12 Elevations and Materials

A_RFMR_9253_C - Planning, Design and Access Statement

61
Pears Building

Fig 35 Proposed Amendment - Elevations and Materials

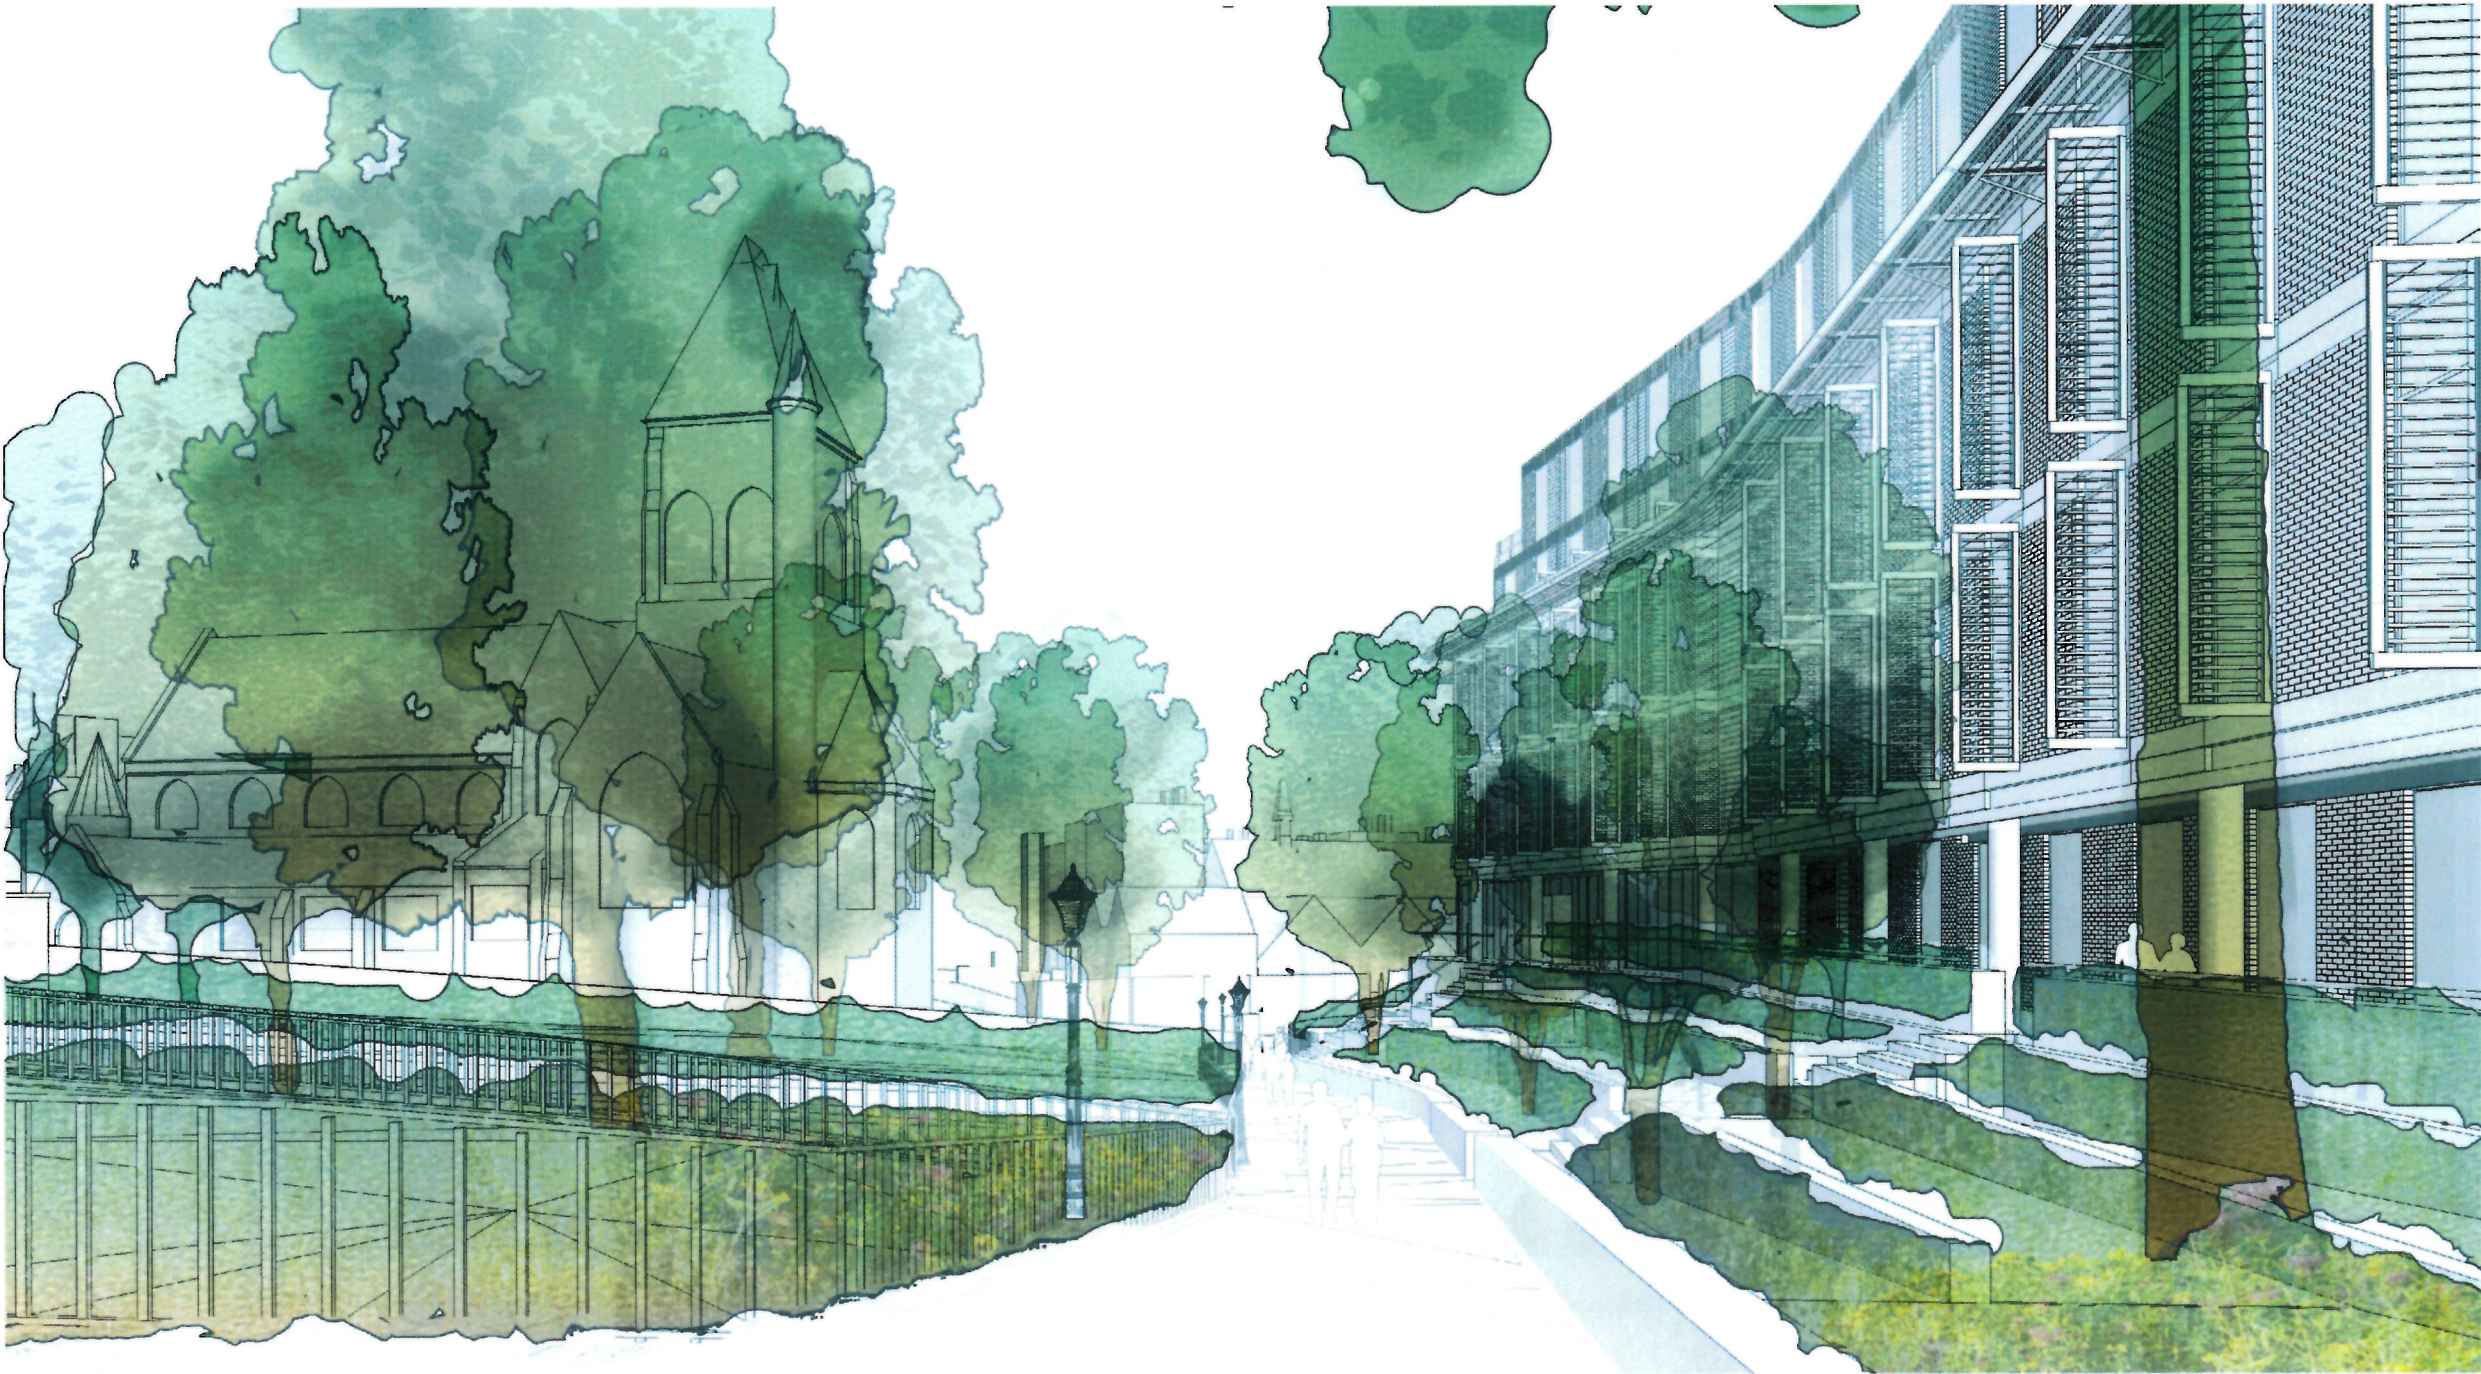
The amended perspective shows the following:

1. The two amended stair locations to the North of the building.
2. The additional accessible carpark space.
3. The removed North courtyard with the path adjacent to the North side of the building retained and the soft landscaping increased.

Fig 37 Proposed Amendment - Elevations and Materials

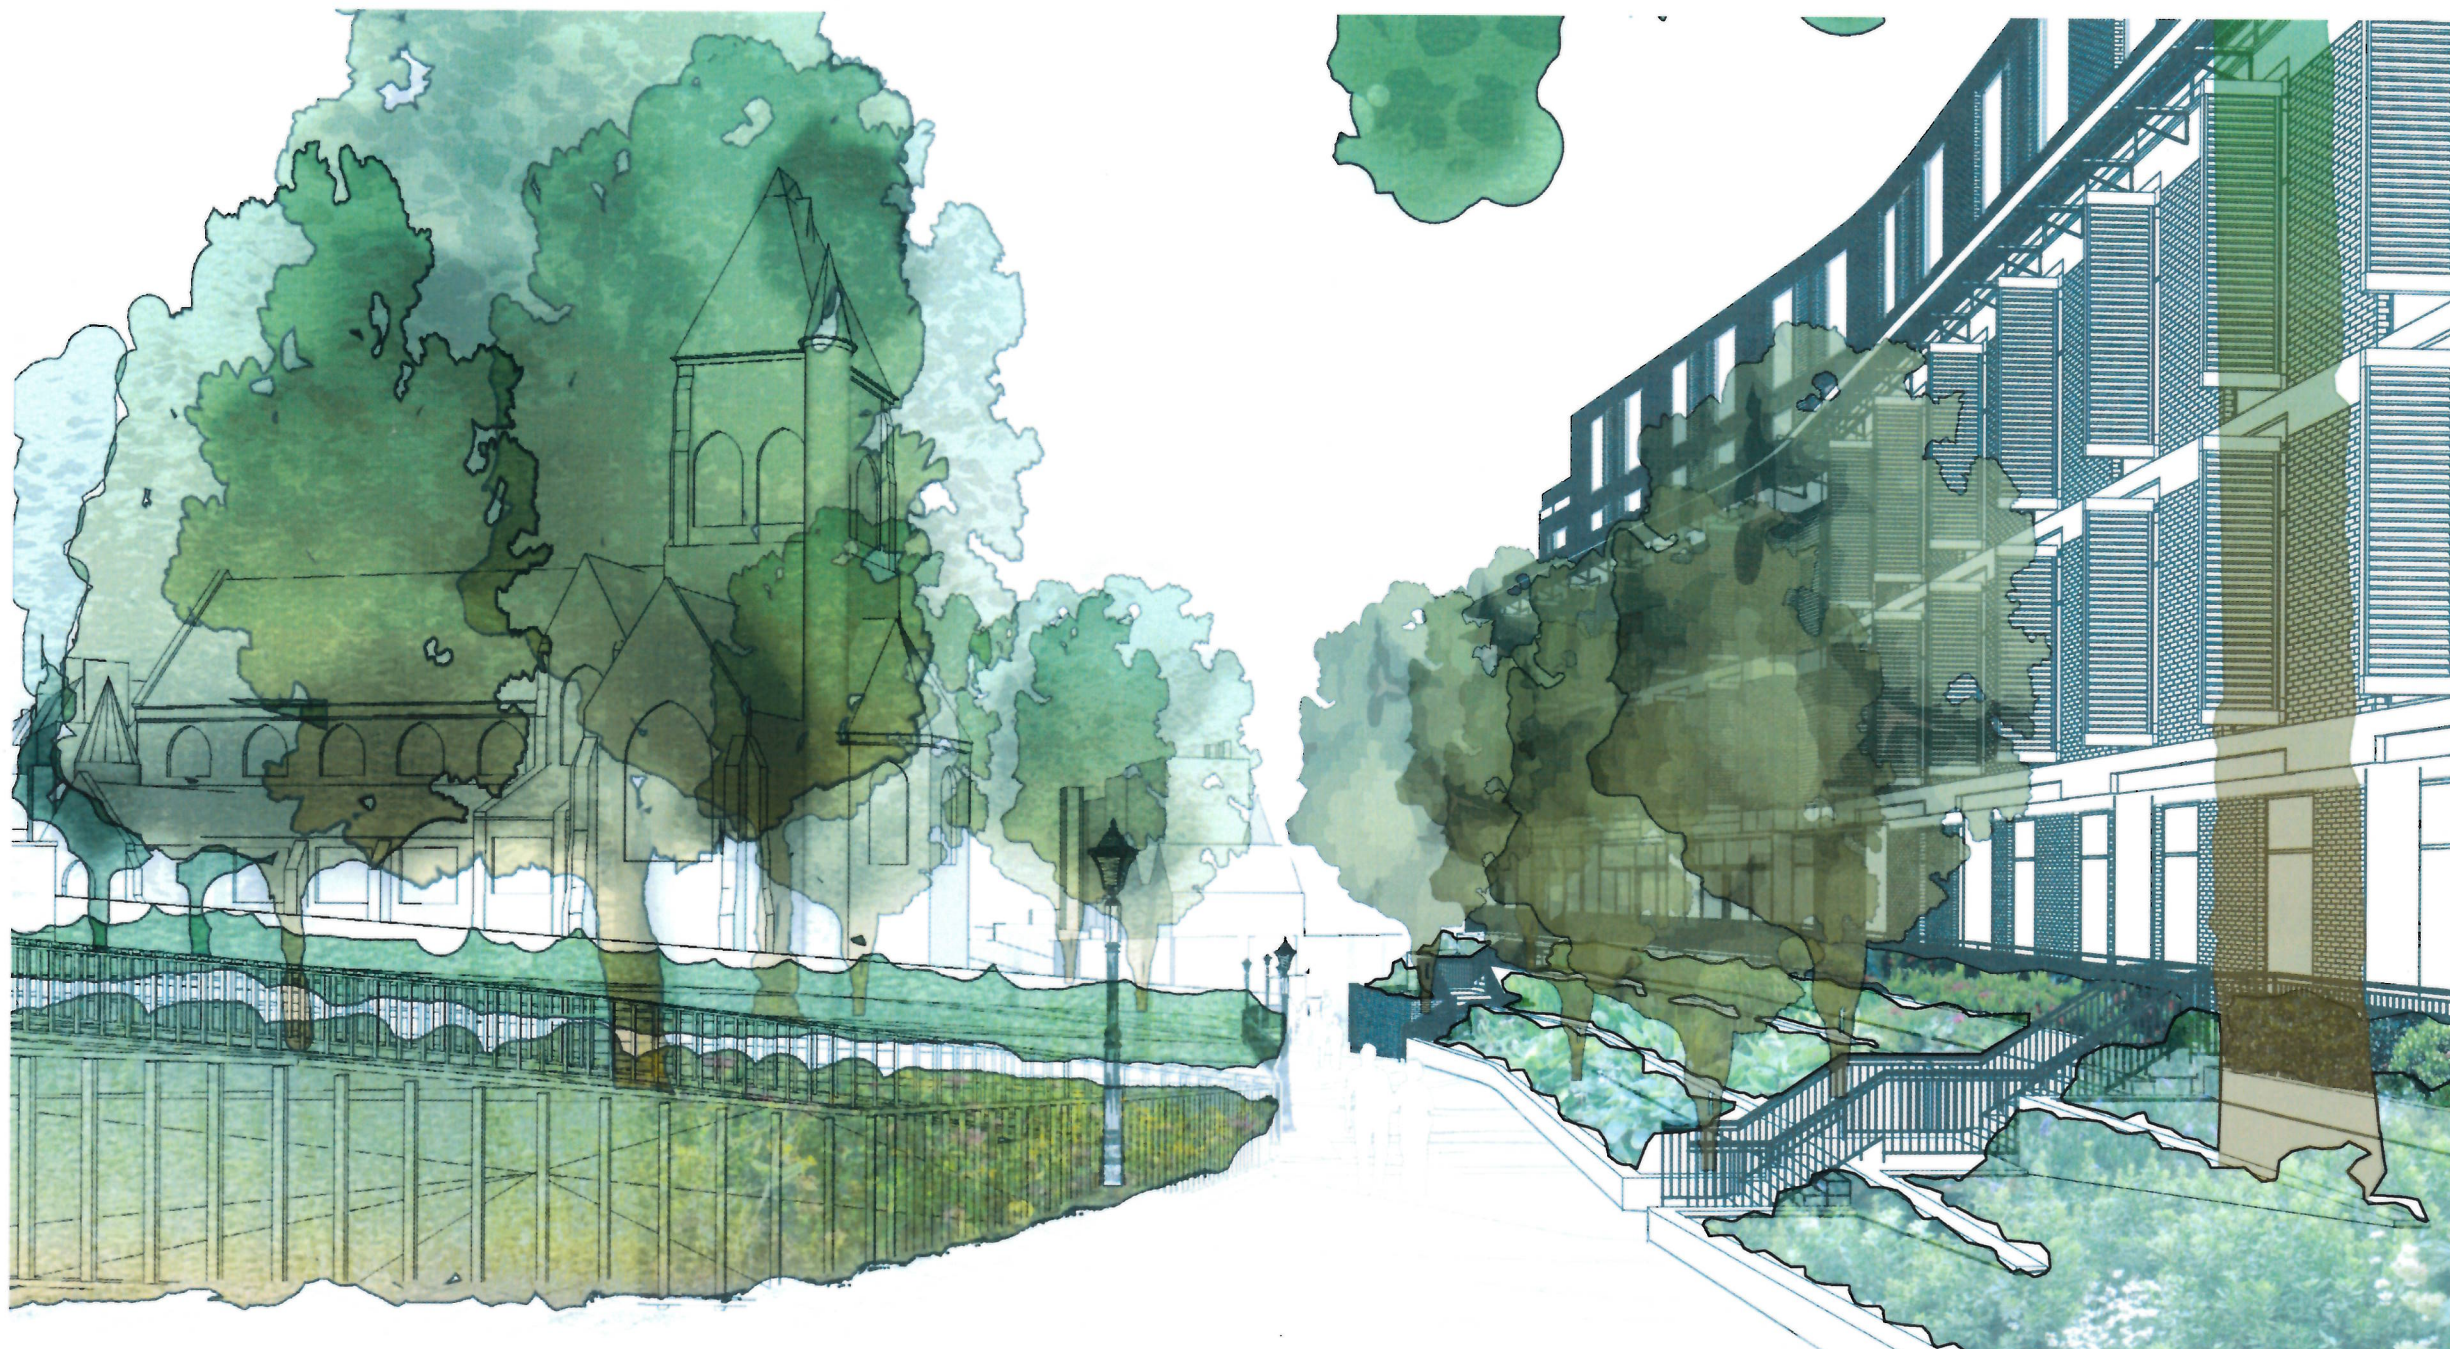
The amended perspective shows the following:

1. The revised width of the public footpath (to return as close as possible to its existing footprint).
2. Revised stairs along the West elevations - changes to stairs required to accommodate the reduced width of the proposed landscape.
3. Revised width of the landscaped external terraces - widths changed locally to allow for the revised width of the public footpath (to return as close as possible to its existing footprint).
